RENESAS TECHNICAL UPDATE

Product Category	MPU/MCU		Document No.	TN-RX*-A0278A/E	Rev.	1.00
Title	Errata Regarding Setting of the RCR4.RCKSEL Bit for the RX64M Group and RX71M Group MCUs		Information Category	Technical Notification		
Applicable Product	RX64M Group, RX71M Group	Lot No.	Reference Document	User's Manual: Hardware for applicable products listed under Related Documents on the last page		
		All

Figure 32.3 Clock and Count Mode Setting Procedure

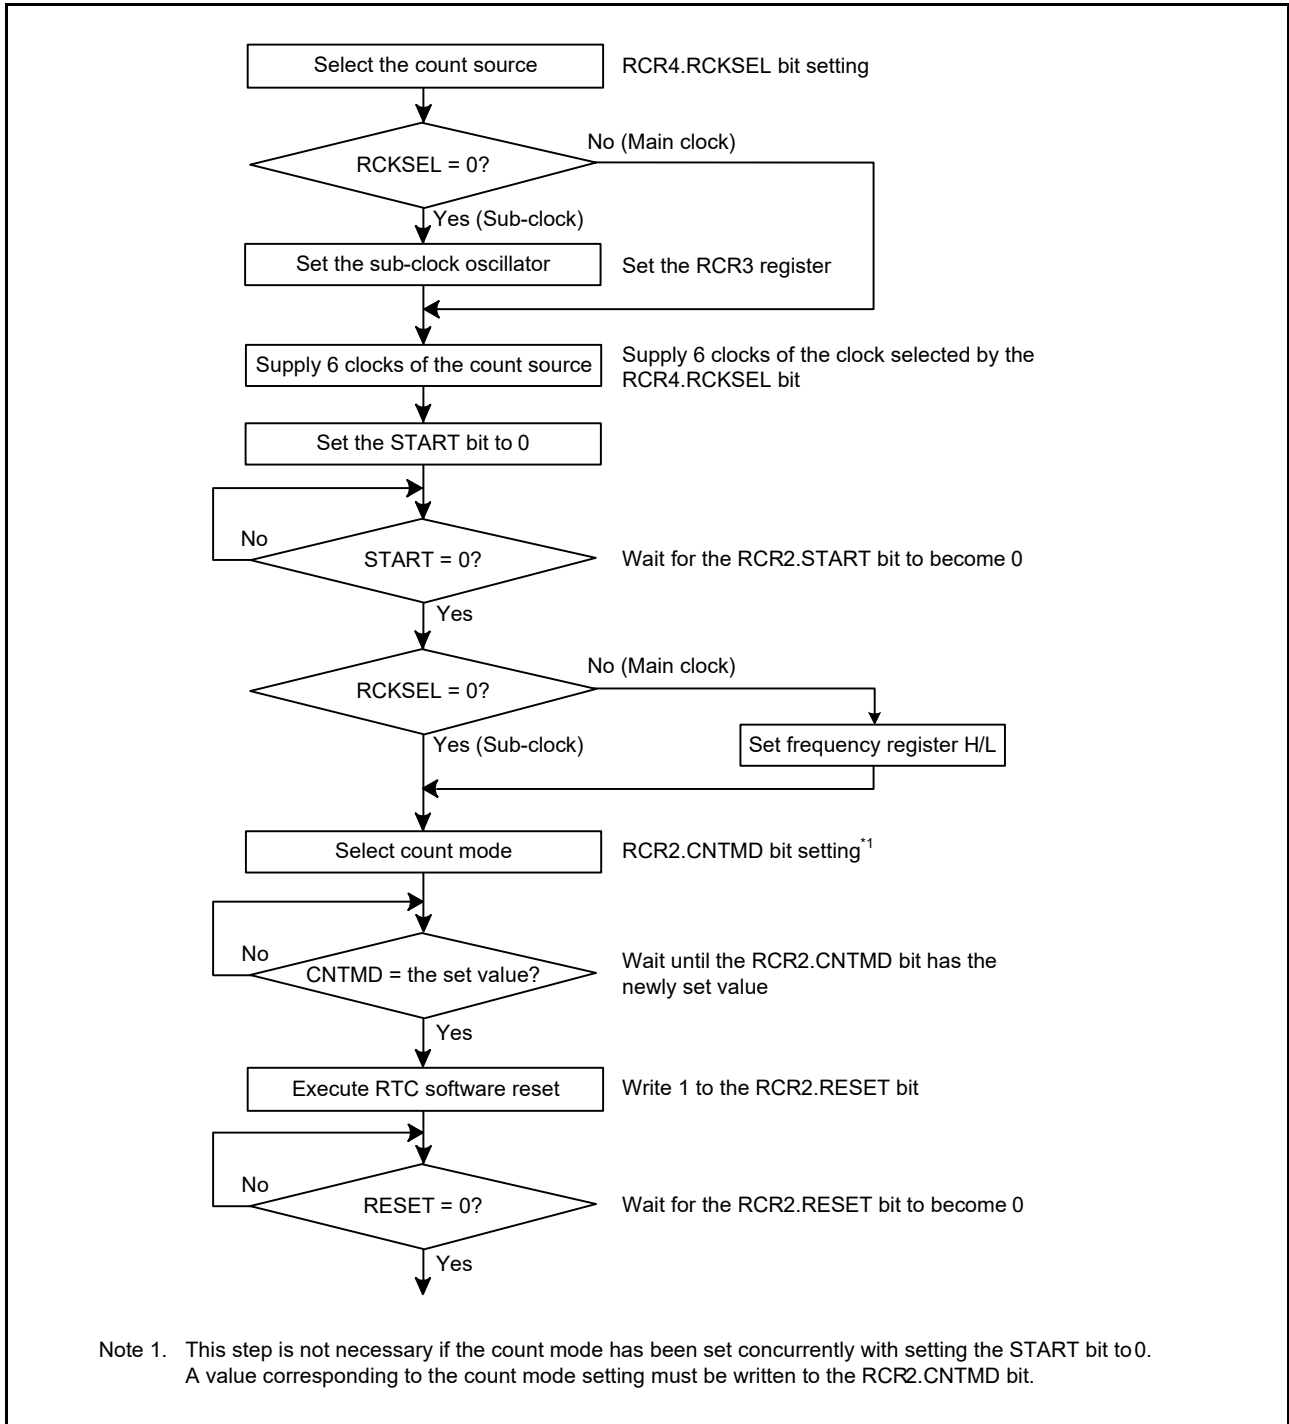
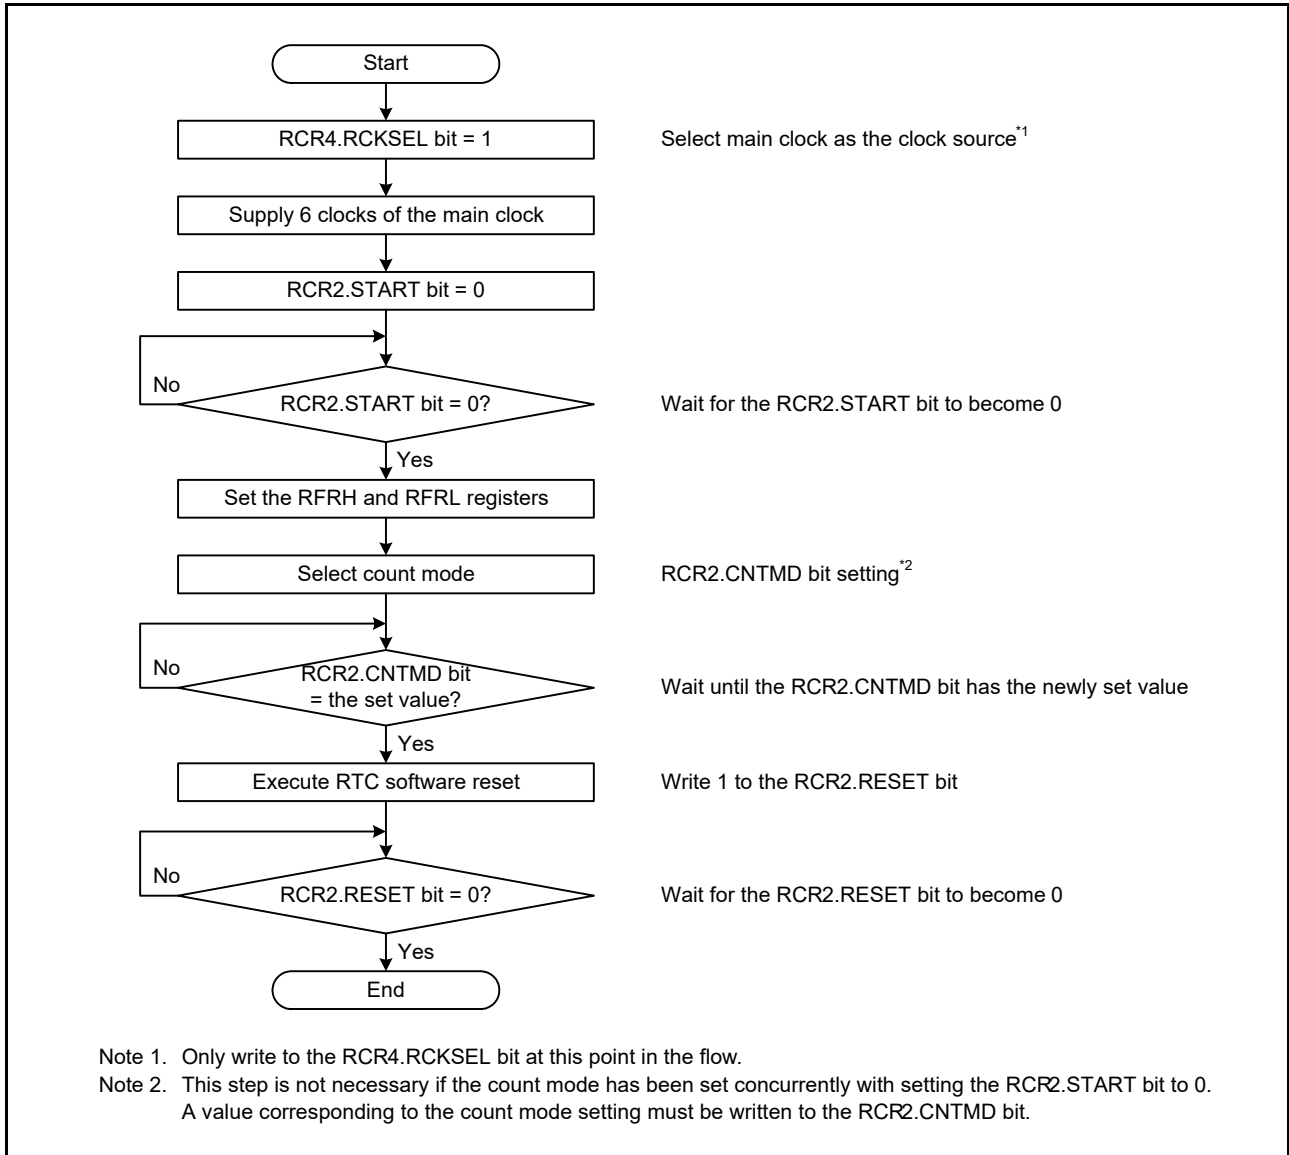
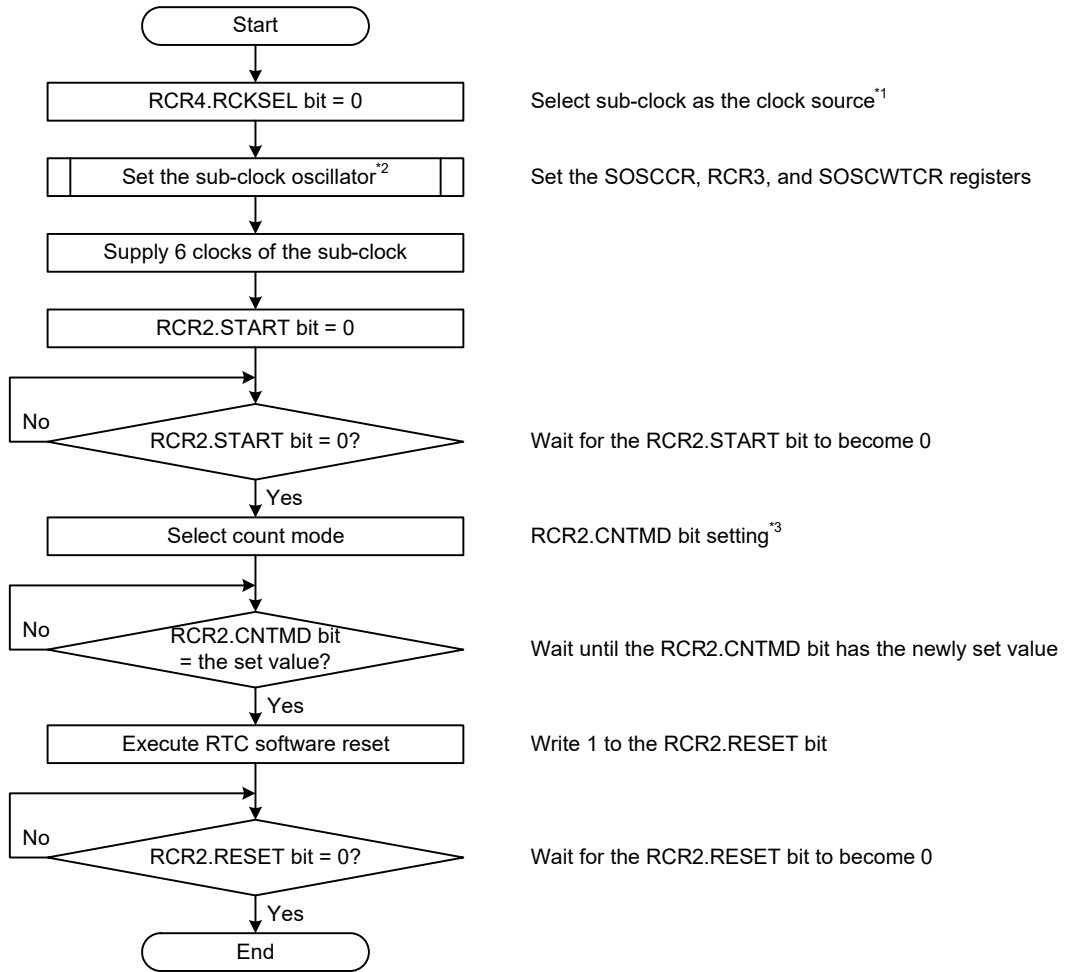
Figure 32.3, Clock and Count Mode Setting Procedure, in section 32.3.2, Clock and Count Mode Setting Procedure, is separated into two flowcharts as follows to suit the clock that is in use.

Note 1. Only write to the RCR4.RCKSEL bit at this point in the flow.

Note 2. For the procedure for setting up a sub-clock oscillator, refer to section 9, Clock Generation Circuit.

Note 3. This step is not necessary if the count mode has been set concurrently with setting the RCR2.START bit to 0. A value corresponding to the count mode setting must be written to the RCR2.CNTMD bit.

Figure 32.14 Initialization Procedure

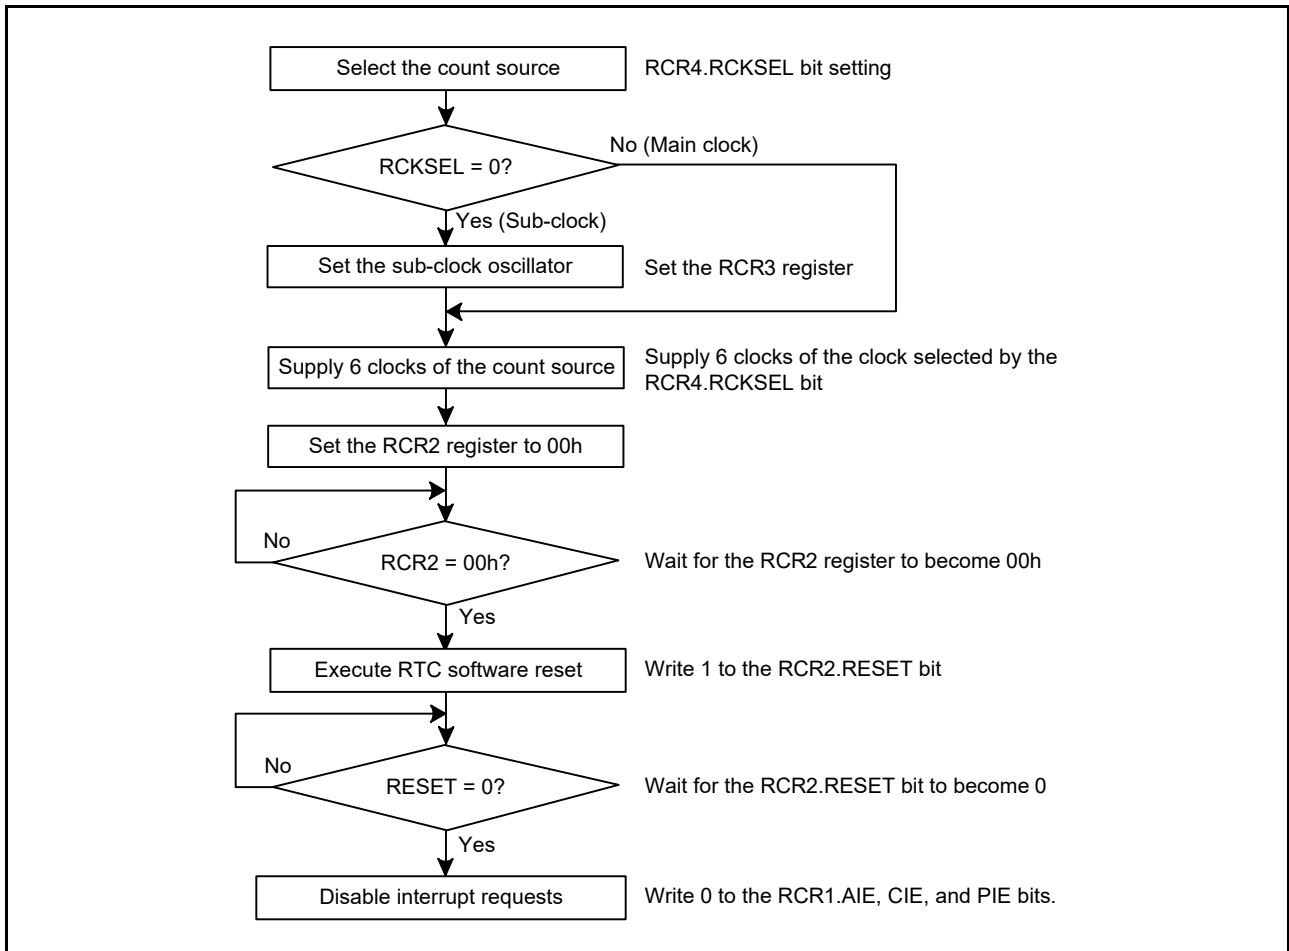
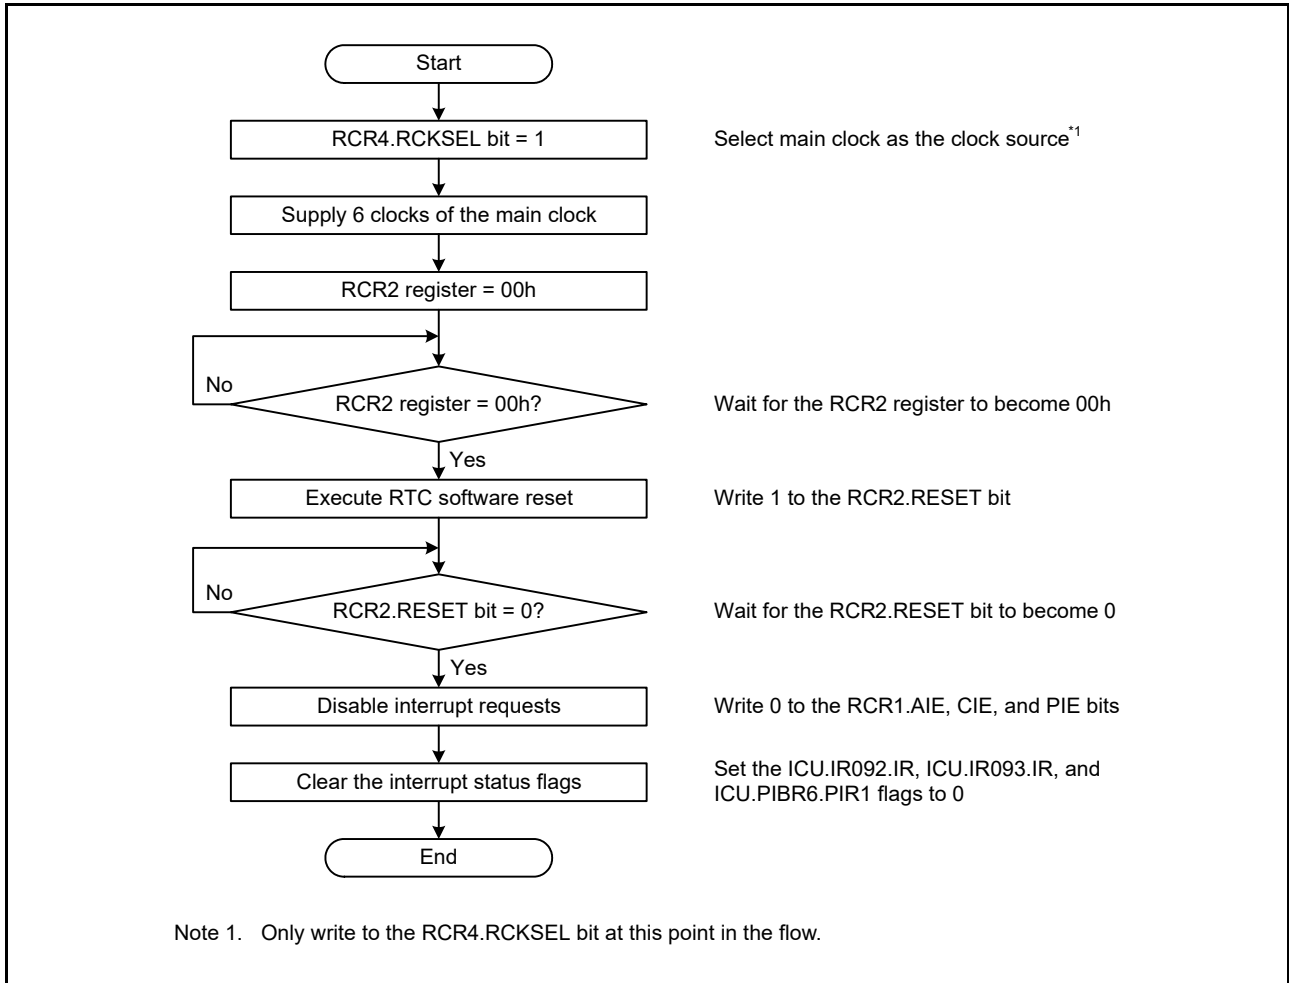
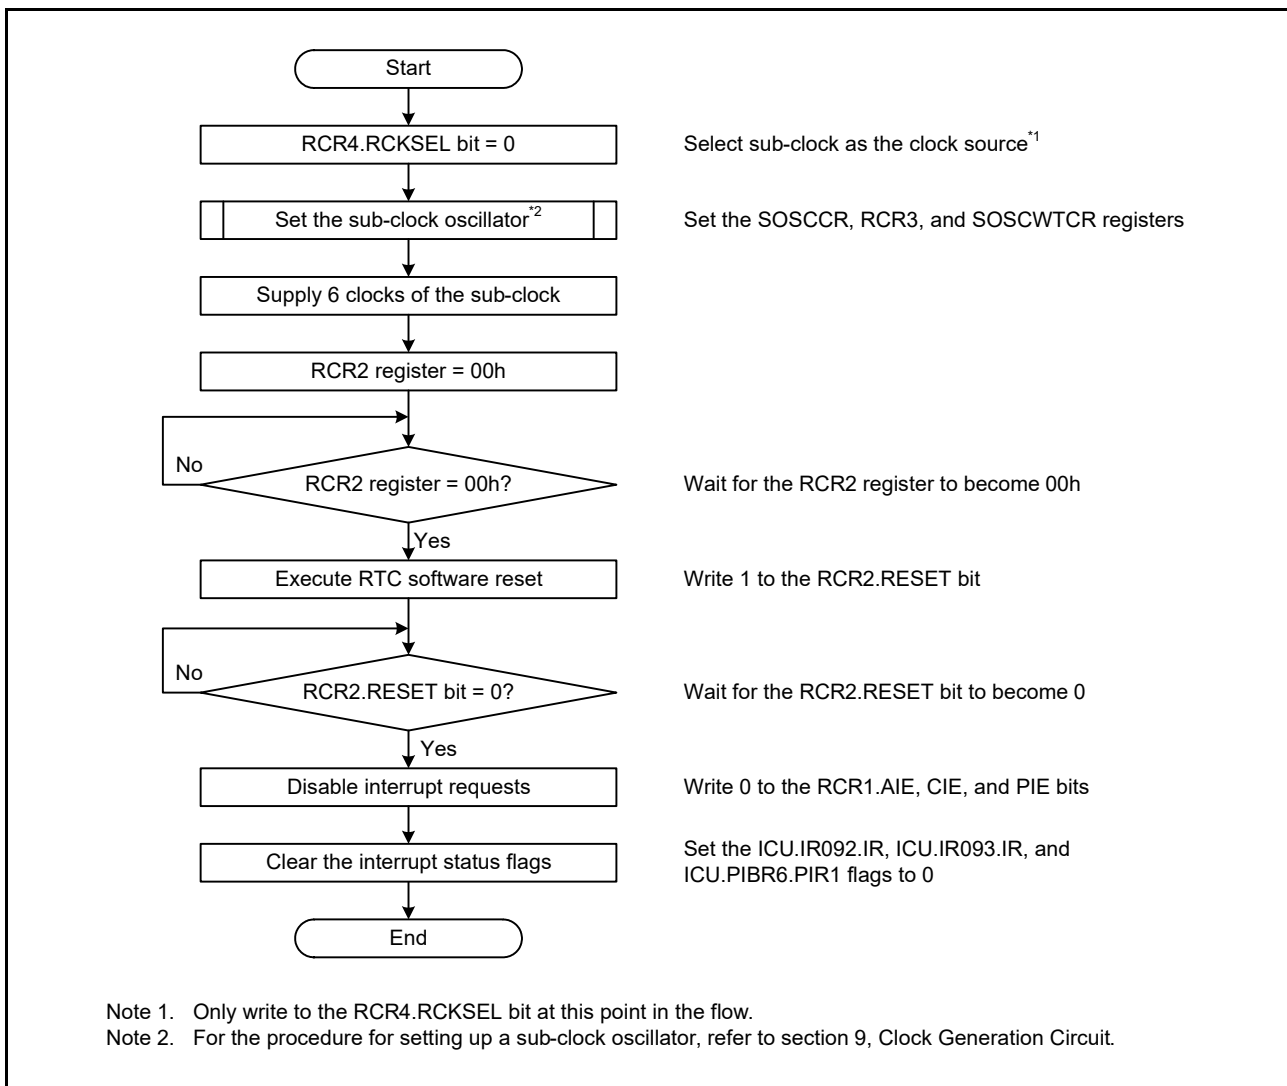
Figure 32.14, Initialization Procedure, in section 32.6.7, Initialization Procedure When the Realtime Clock is Not to be Used, is separated into two flowcharts as follows to suit the clock that is in use. A step of clearing the interrupt status flags is also added to both flowcharts.
